INDESIT company

TCM711EU/HA

F048892

07333-20 Exploded views

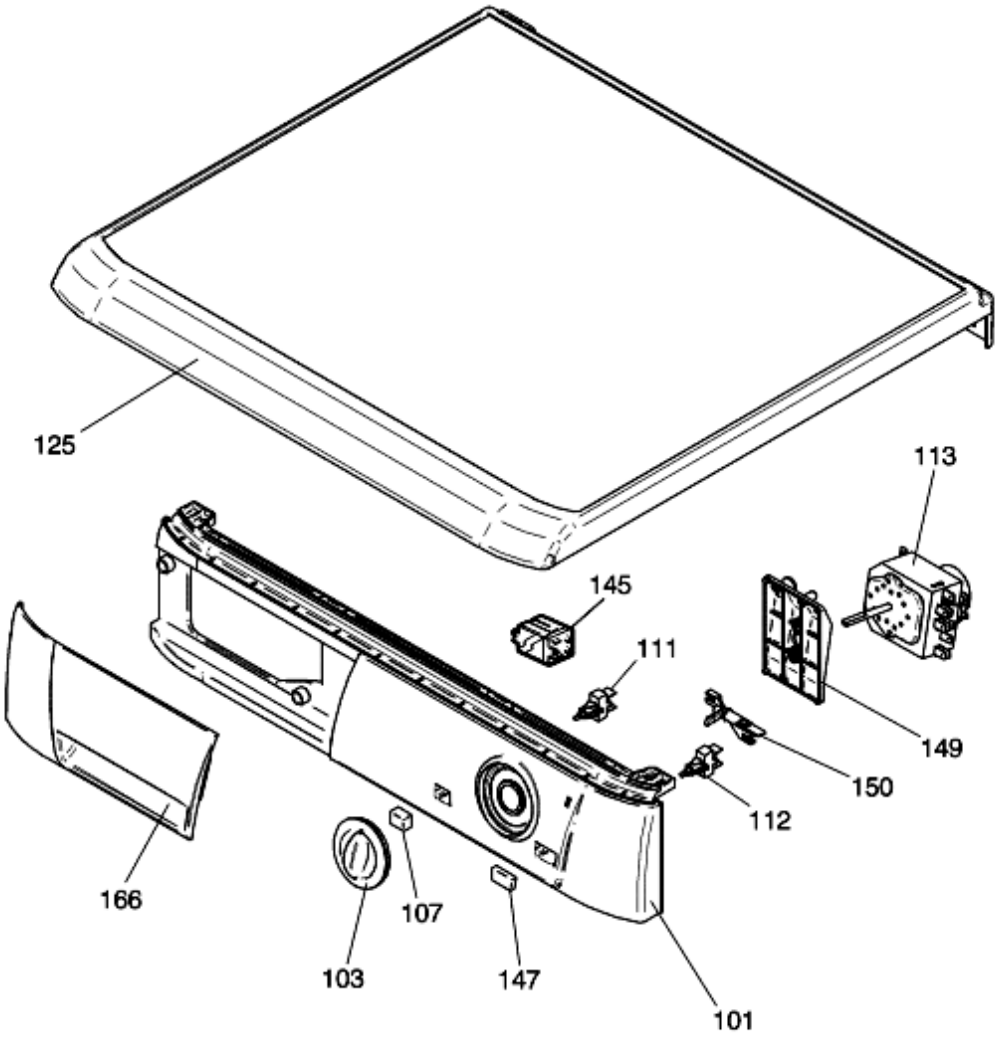
n4408l00: DRUM ASSEMBLY WITH FIXED SHAFT

From Serial Number 80901.0001 a new drum with a fixed (Rivetted) shaft has been introduced in production, this drum is interchangeable and will be supplied as the service spare.

Please Note;
There are 2 drum shaft repair kits
Repair Kit for Drums with a Screwed Drum Shaft
Repair Kit for Drums with a Rivetted Drum Shaft
Select the correct kit from the parts list

Note: Only use the correct kit for the Drum fitted to the Dryer.

n4411j00: PATTERN DRUM INTRODUCED

FROM OCTOBER 2011 A PATTERN DRUM HAS BEEN USED IN PRODUCTION.
THE PATTERN DRUM IS INTERCHANGABLE WITH THE PREVIOUS PLAIN DRUM.
ONCE STOCKS OF THE PLAIN DRUM ARE EXHAUSTED.
THE PATTERN DRUM WILL BE THE SERVICE SPARE.

NOTE
TWO PLAIN DRUMS WERE USED IN PRODUCTION.
THE DRUM SHAFT CAN ONLY BE REPLACED IF THE ORIGINAL DRUM TO SHAFT FIXING IS SCREWED. IF THE DRUM SHAFT IS RIVETED TO THE DRUM, THE COMPLETE DRUM HAS TO BE REPLACED.

n4413j00: BREAKING BELTS

To overcome the issue of breaking belts the 6 Rib belt has been replaced by the 8 rib belt C00300793

12721-15 Exploded views

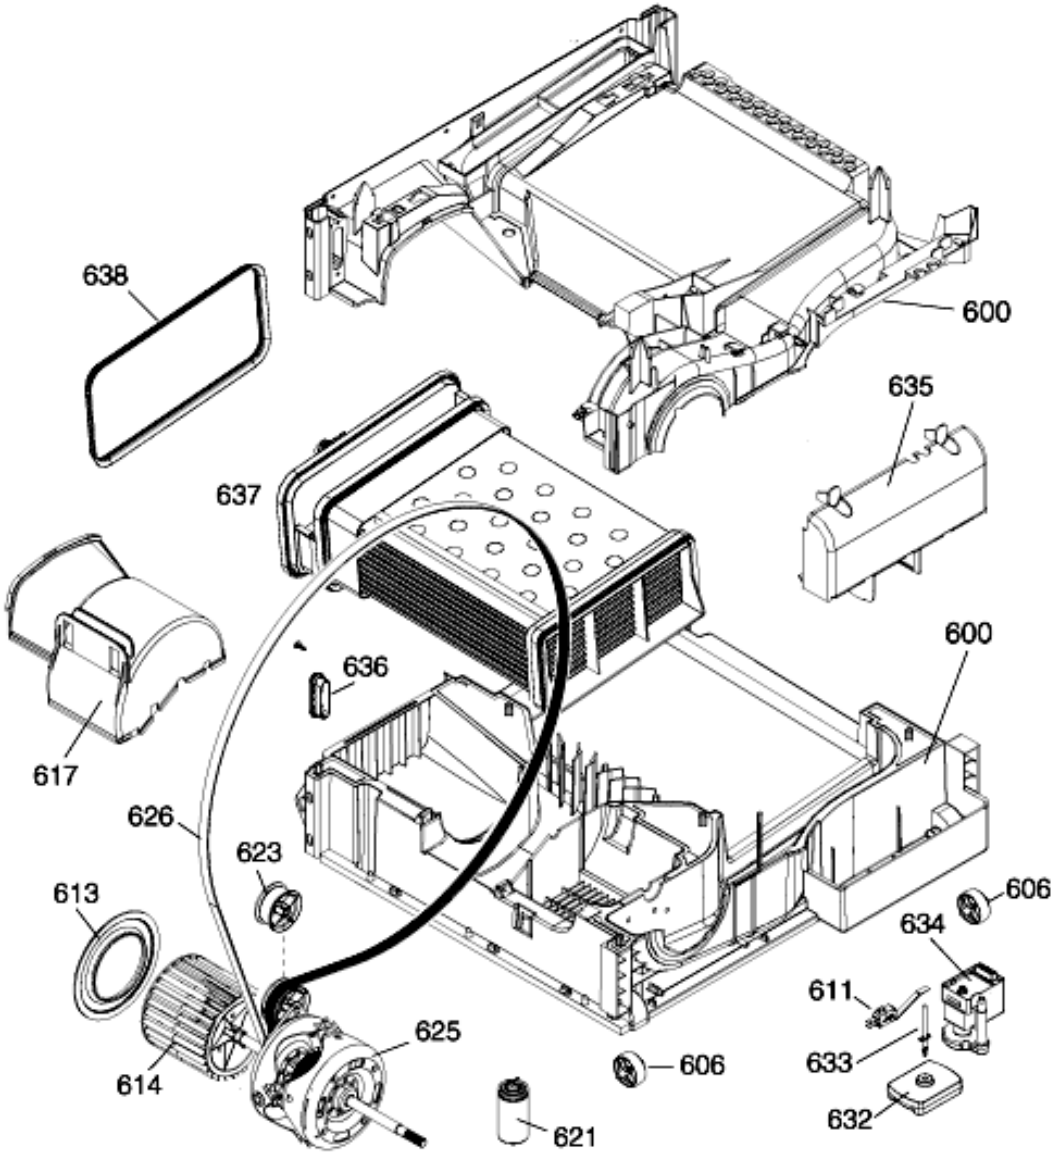
n4411g07: CONDENSER FRONT AIR DUCT COLOUR CHANGE

FROM JUNE 2011 THE FRONT AIR DUCT FITTED TO CONDENSER TUMBLE DRYERS CHANGED IN PRODUCTION FROM GREY TO WHITE.
SELECTED THE CORRECT PART BY DESCRIPTION IN THE PARTS LIST
